UNITED STATES PATENT AND TRADEMARK OFFICE

Office Action Summary	Application No. 10/637,191	Applicant(s) MULLER, JURGEN	
	Examiner Phillip Nguyen	Art Unit 2828

DETAILED ACTION

Figure 2

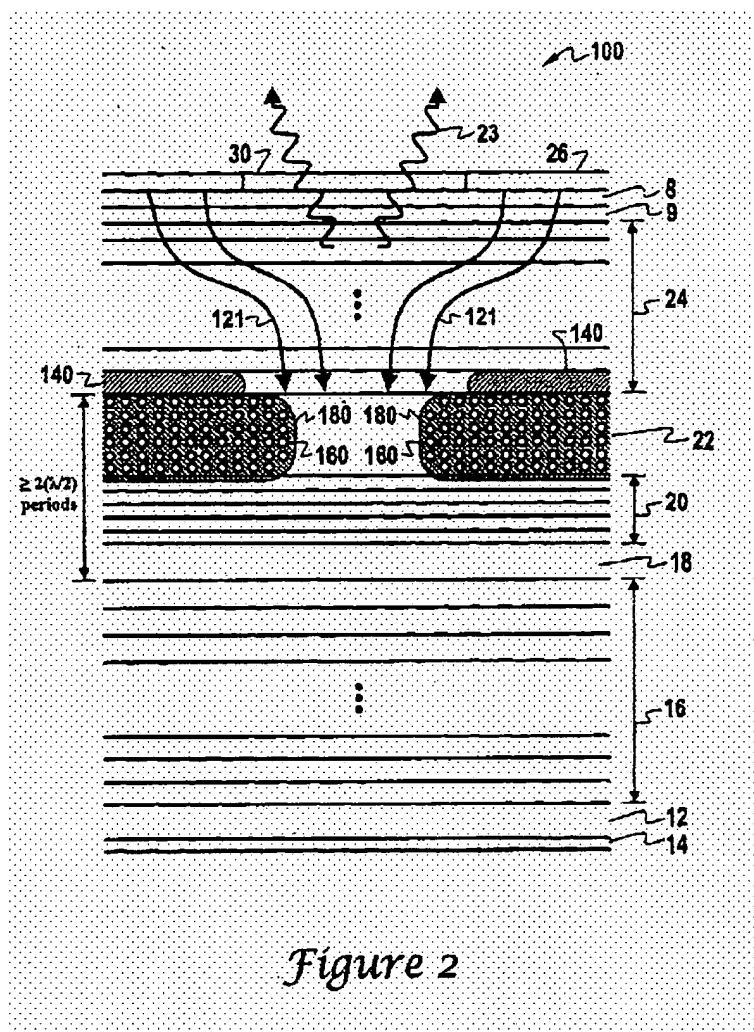
Claims 1, 4, 8, 10, and 12 are rejected under 35 U.S.C. 102(e) as being anticipated by Cox et al. ('072).

With respect to claim 1, Cox discloses in Fig. 2 above a semiconductor laser comprising:
a vertical resonator formed by reflectors 16 and 24; a photon-emitting active layer disposed
between said at least one current diaphragm 140 for laterally circumscribing a current flowing

through said photon-emitting active layer and mode-selective regions 160 and 180 extending in a vertical direction within said vertical resonator and laterally delimiting said vertical resonator, said mode-selective regions-being implantation regions extending into said photon-emitting active layer.

With respect to claim 10, it is also inherent that the vertical cavity having an edge area (outside edge) and mode selective region 22 (more specific, 160 and 180) that extends in said edge area and a surrounding region of said edge area of said vertical resonator which is any region that is different from edge area.

With respect to claim 12, see the Fig. 2 for multilayer structure and the mode-selective regions 22 being disposed within that multilayer structure.
